CITY OF ALBUQUERQUE

Re: Restaurant 6000 Montgomery Boulevard Traffic Circulation Layout Engineer's/Architect's Stamp 1-14-2021 (G18-D042)

TRAFFIC CIRCULATION LAYOUT APPROVED 1/19/21

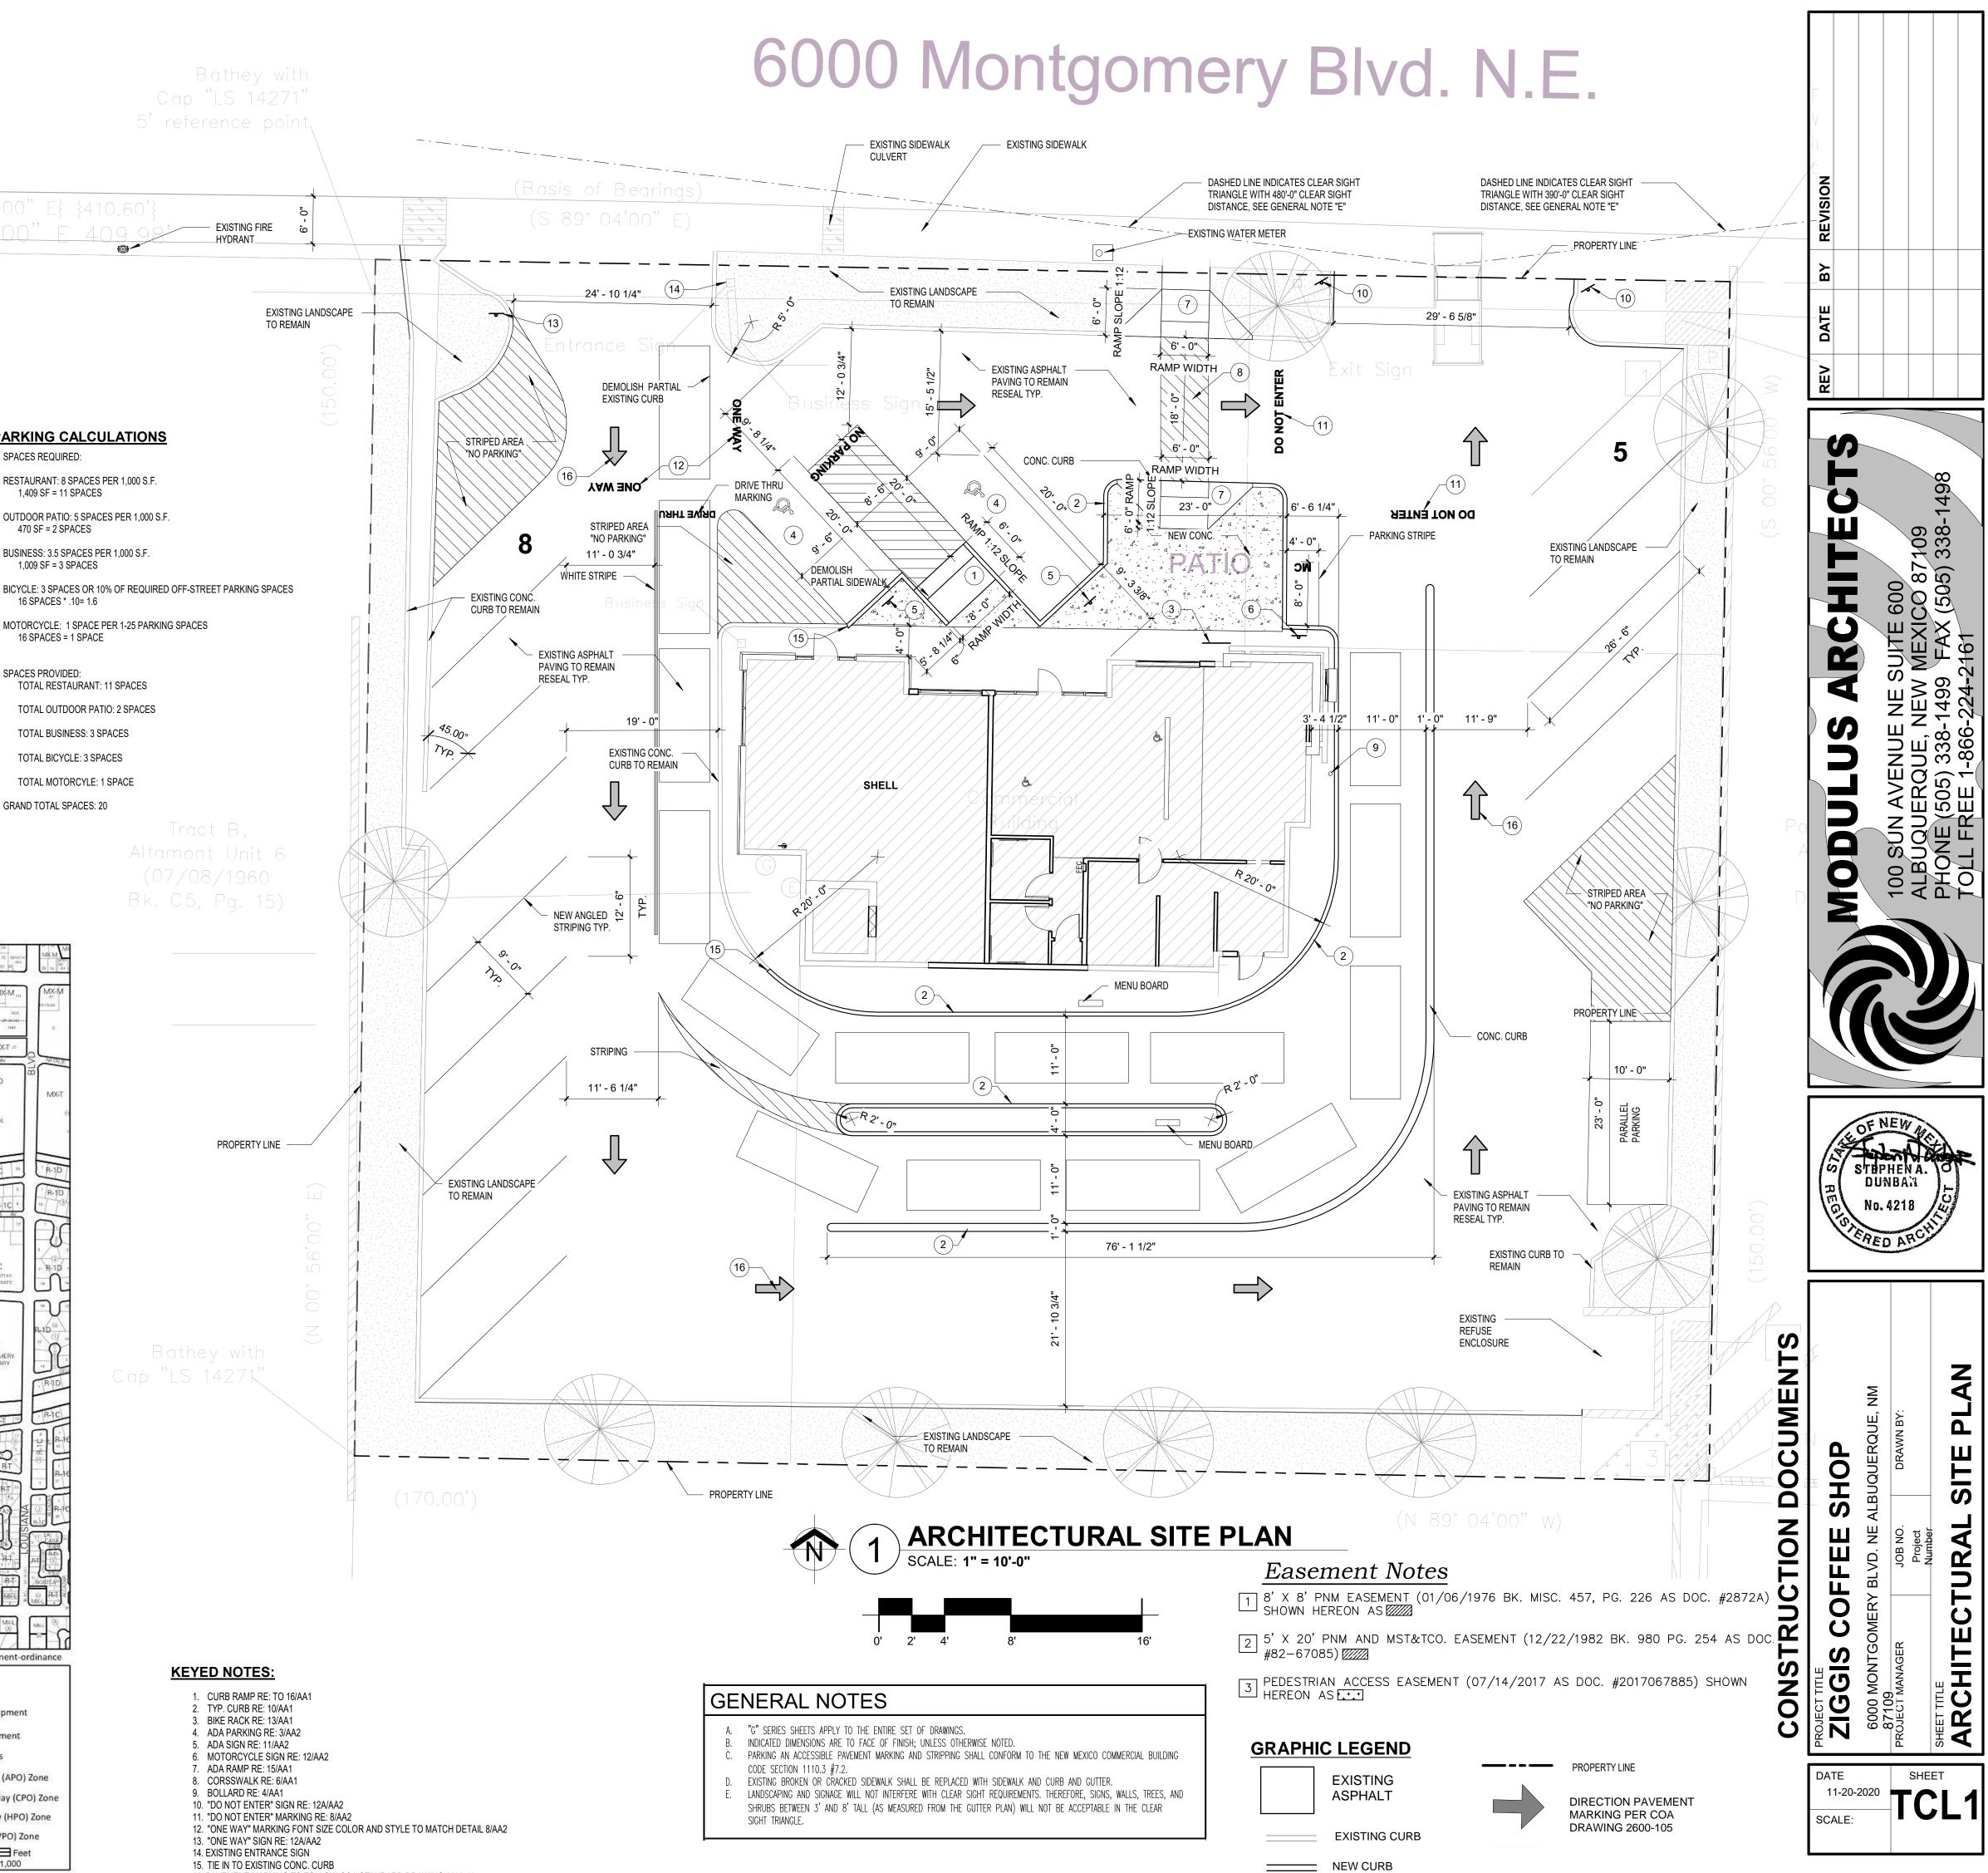
The TCL submittal received 1-14-2021 is approved for Building Permit with. A copy of the stamped and signed plan will be needed for each of the building permit plans. Please keep the original to be used for certification of the site for final C.O. for Transportation.

PO Box 1293When the site construction is completed and an inspection for Certificate of Occupancy (C.O.) is
requested, use the original City stamped approved TCL for certification. Redline any minor changes and
adjustments that were made in the field. A NM registered architect or engineer must stamp, sign, and
date the certification TCL along with indicating that the development was built in "substantial
compliance" with the TCL. Submit this certification, the TCL, and a completed Drainage and
Transportation Information Sheet to front counter personnel for log in and evaluation by
Transportation.
